CHANGE ORDER NUMBER: 5

Project Name: Corridor H - Sam Bass Road

Corridor H – Sam Bass Road Williamson County Project No. 23IFB8

Change Order No. 5

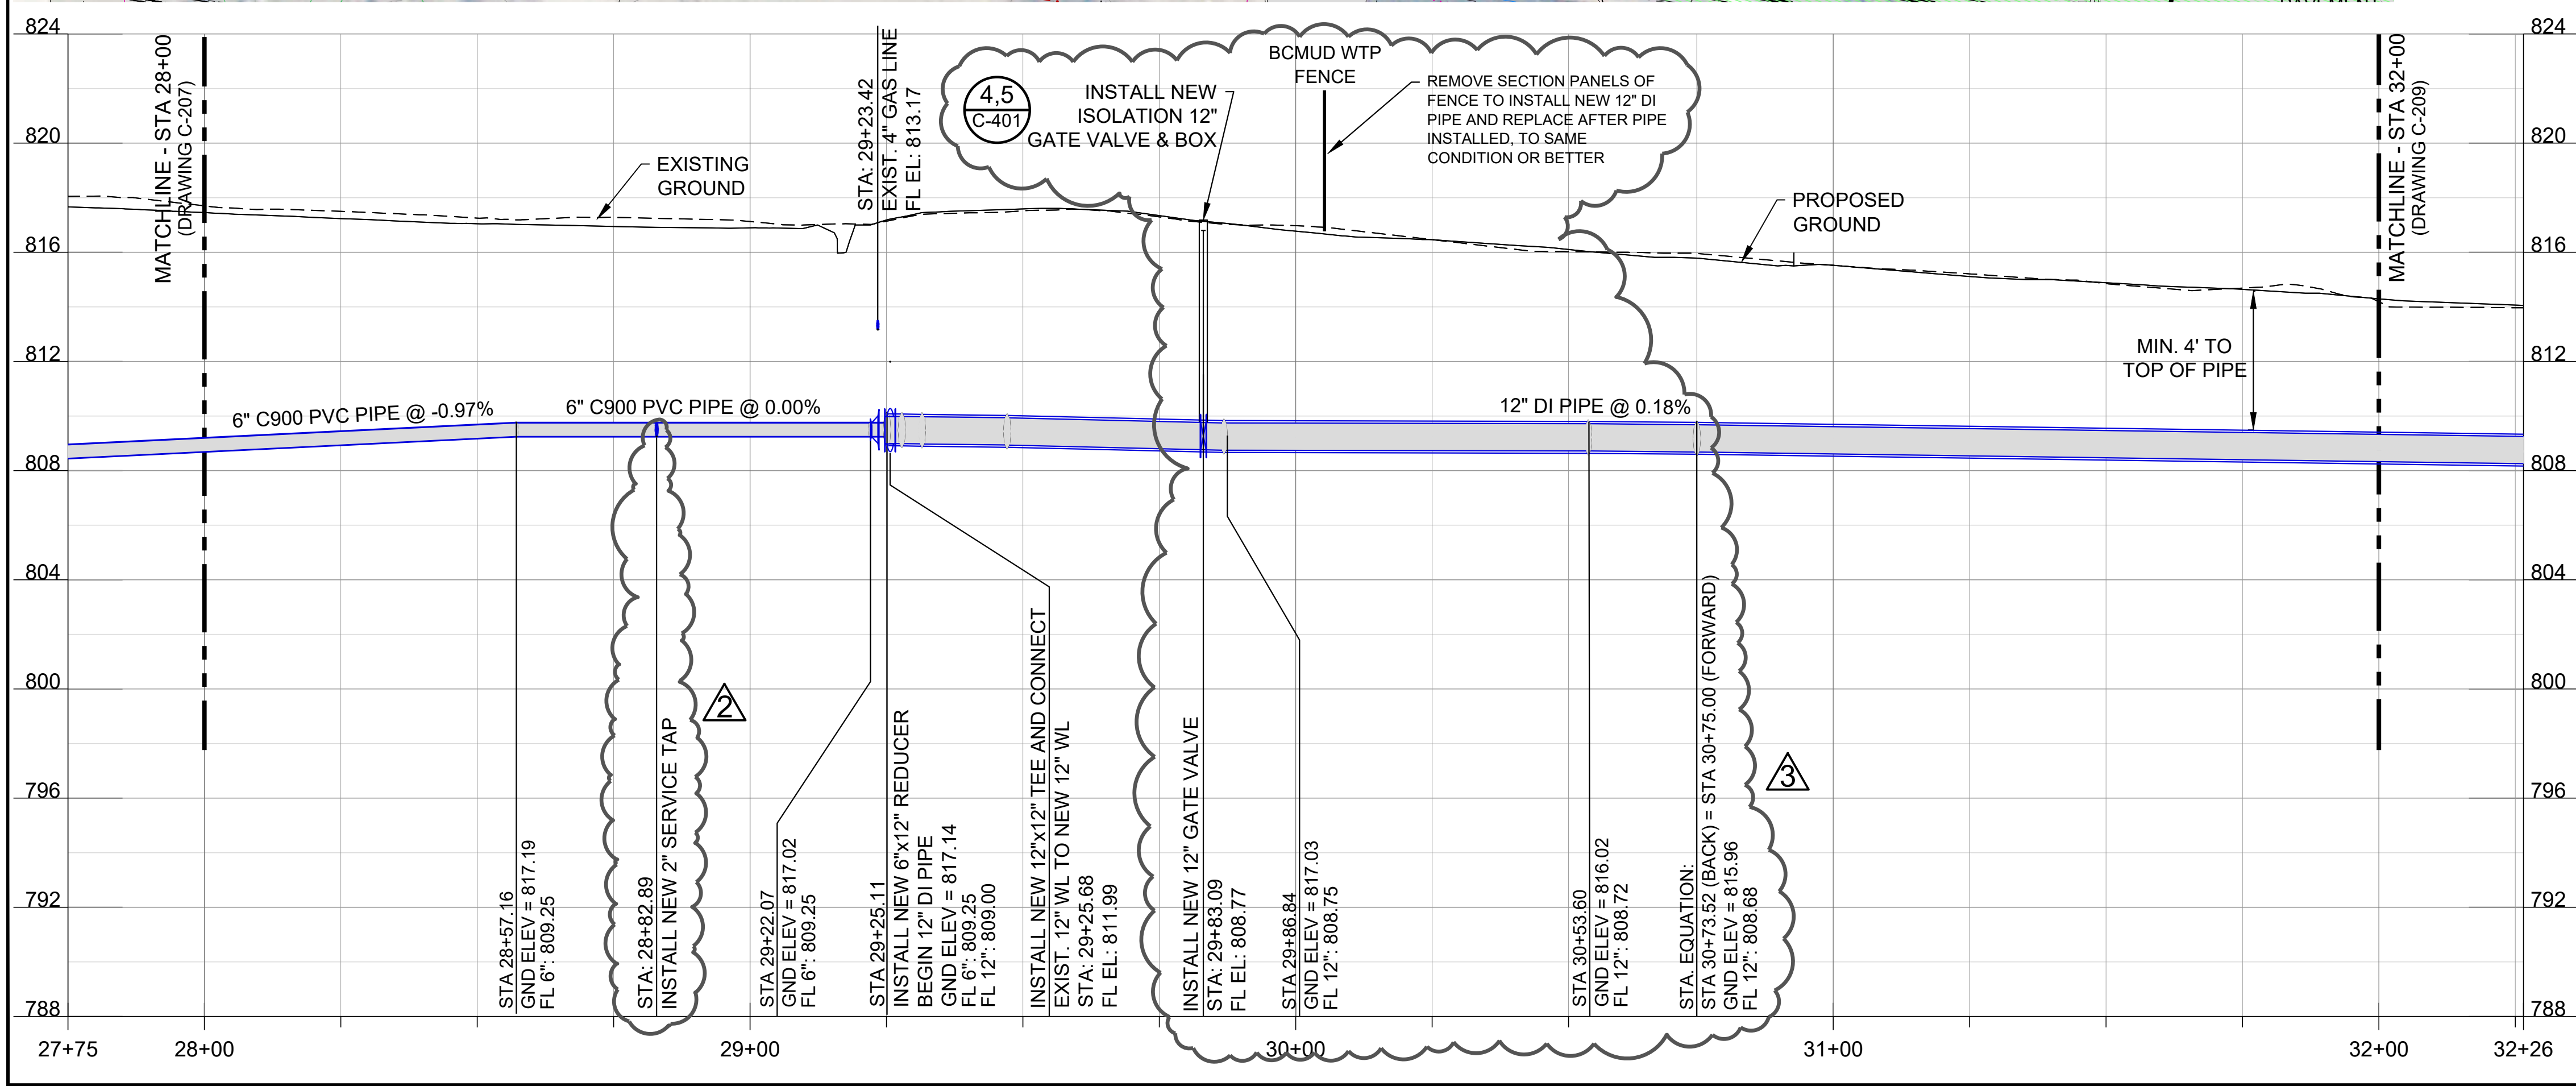
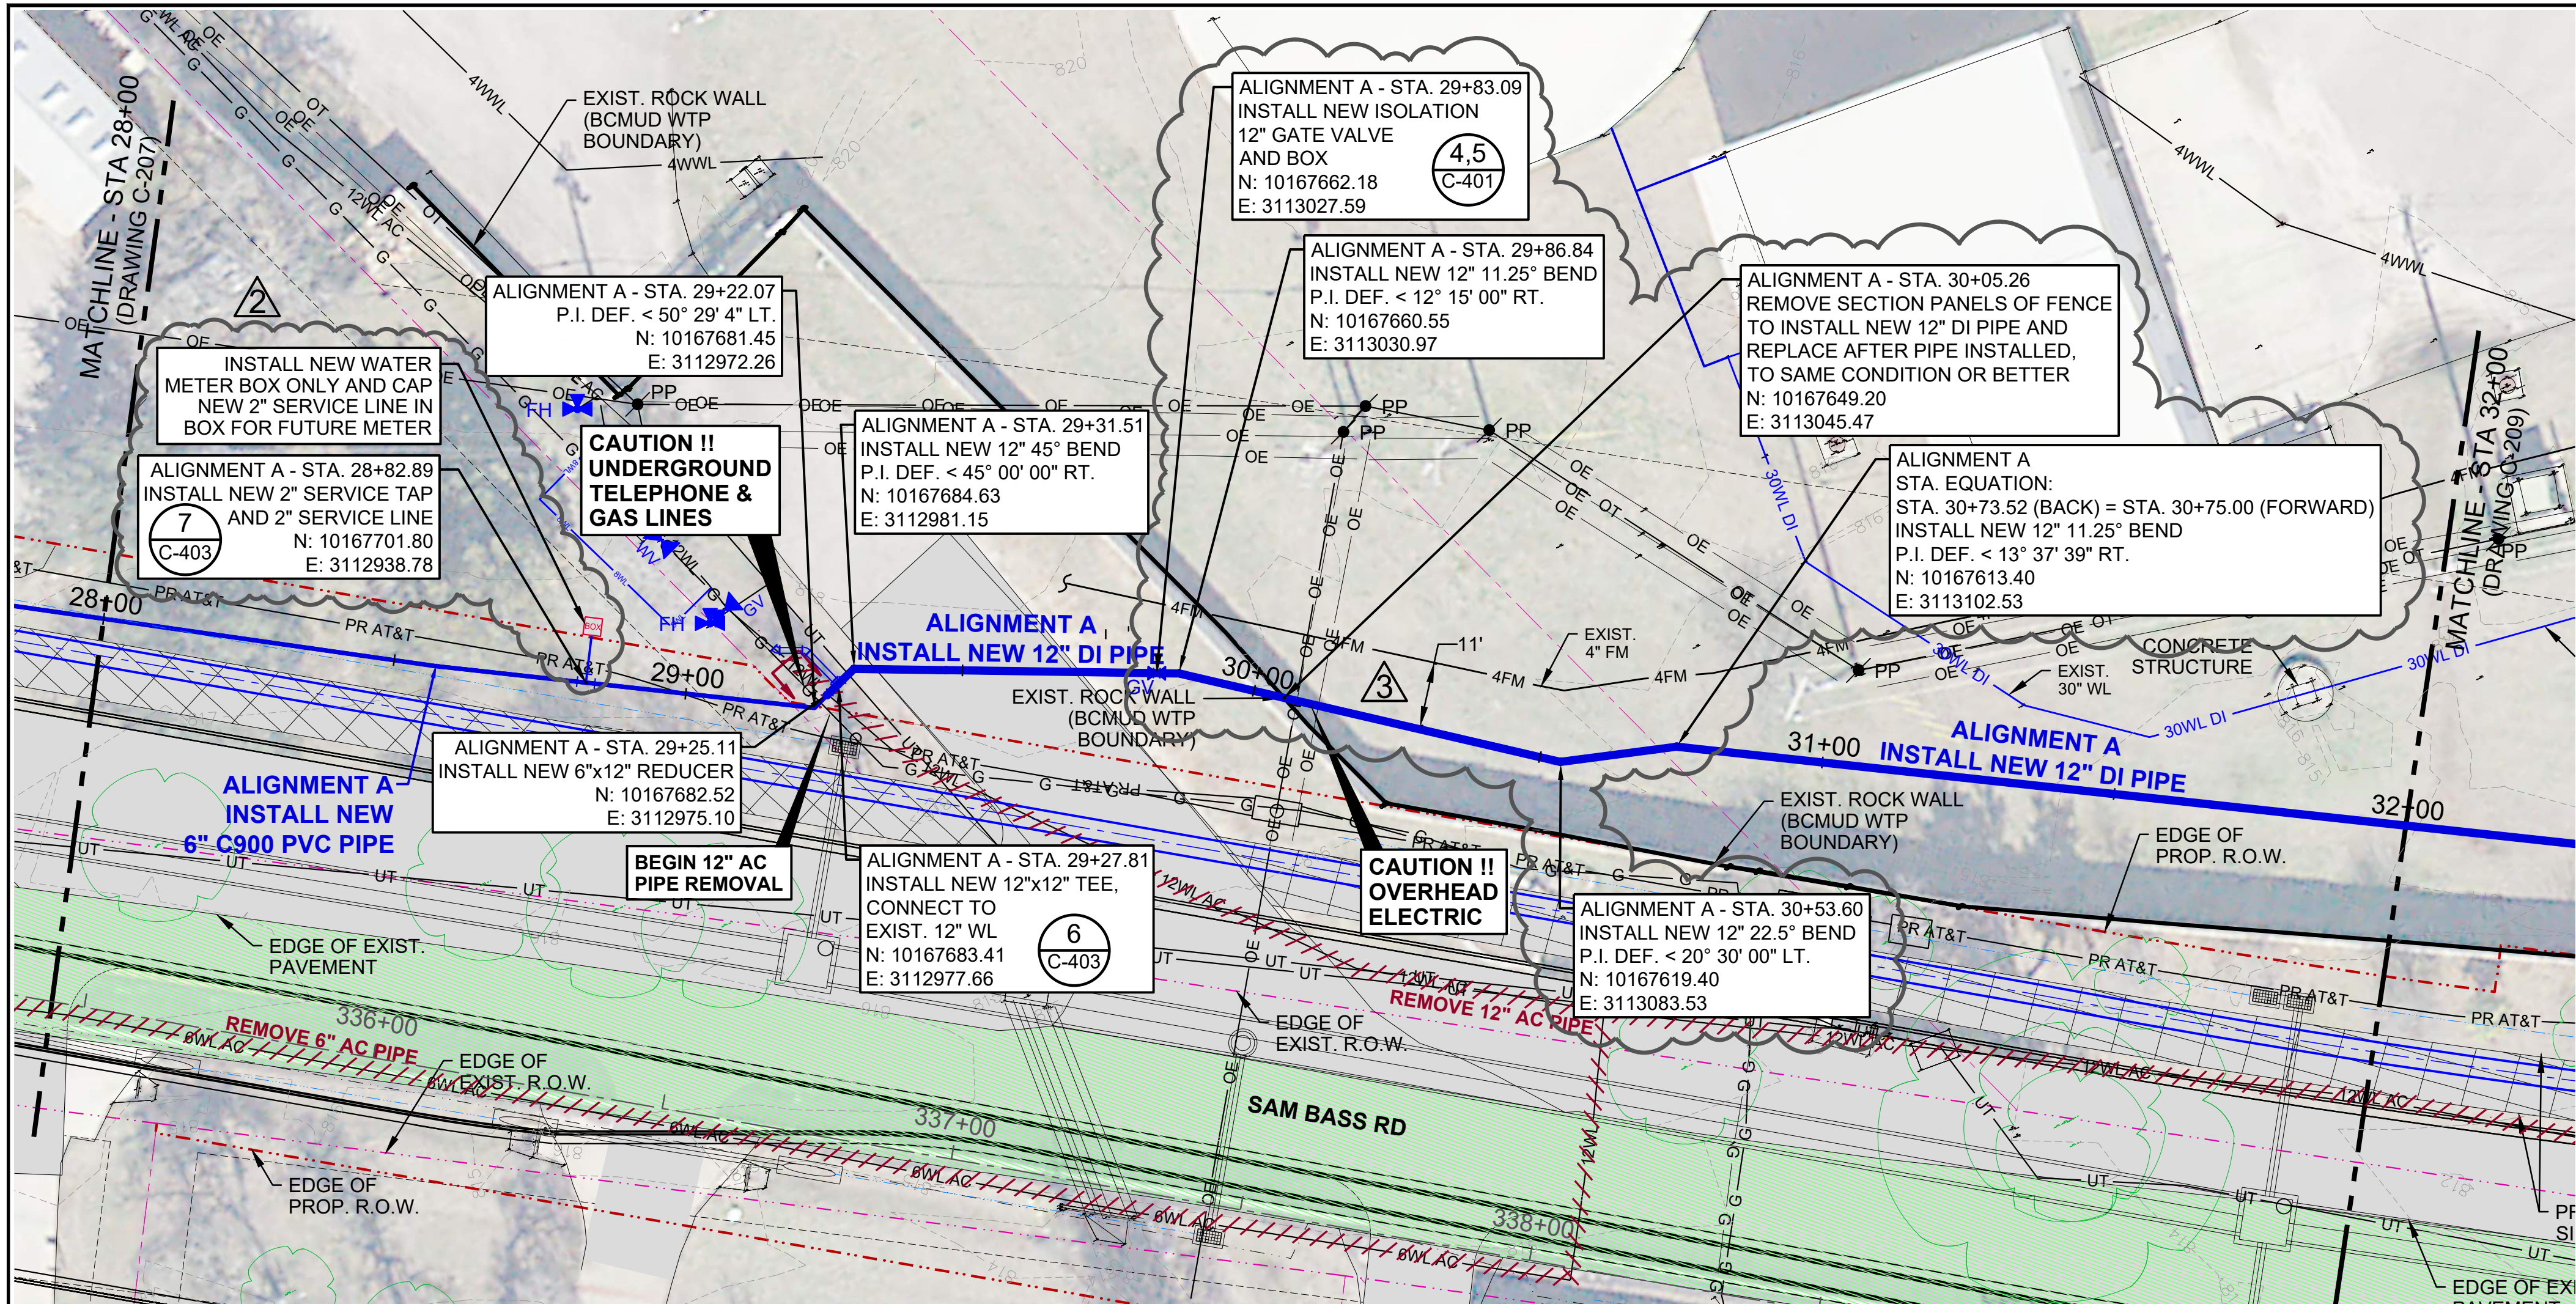
1A. Design Error or Omission. Incorrect PS&E. & 2G. Differing Site Conditions. Unadjusted utility (unforseeable): This Change Order adds items to compensate the contractor for field adjustments on the BCMUD water line alignment to solve conflicts with existing utilities within the BCMUD water plant and the realignment of the proposed water line at the SW corner of Sam Bass Rd and Tonkawa Trail to remain inside the Right-Of-Way limits. This Change Order also compensates the Contractor for installing additional water services requested by BCMUD and for repairing several leaks on the existing water line to maintain service to BCMUD customers.

This Change Order compensates the contractor for work related to the field adjustments on the BCMUD water line alignment to solve conflicts with existing utilities within the BCMUD water plant and the realignment of the proposed water line at the SW corner of Sam Bass Rd and Tonkawa Trail to remain inside the Right-Of-Way limits. This Change Order also compensates the Contractor for installing additional water services requested by BCMUD and for repairing several leaks on the existing water line to maintain service to BCMUD customers.

BRUSHY CREEK MUD SAM BASS RD UTILITY RELOCATIONS ROUND ROCK, TEXAS		3 MODIFY 12" WL ALIGNMENT TEC 12/15/2023		2 INSTALL NEW SERVICE TAP, SERVICE TEC 8/4/2023		1 LINE AND METER BOX TEC 2/14/2023		ADD NOTE 6. EROSION CONTROL By Date	
Drawn By: RPS		Checked By: TEC		Scale: AS SHOWN		Date: JANUARY 2023		Copyright © 2023 MRB GROUP, P.C. All Rights Reserved	
THOMAS E. CAPONI 54723 LICENSED PROFESSIONAL ENGINEER STATE OF TEXAS		MRB Group, P.C. 8834 N. Capital of Texas Hwy, Suite 220, Austin, TX 78759 Phone: 512-436-8571 3003 W. Calhoun Ave. Temple, TX 76788 Phone: 254-771-2054 TBPELS Firm Number: 1-10615 www.mrbgroup.com		Sheet No. 15 of 34		Project No. 0226.21003		C-208
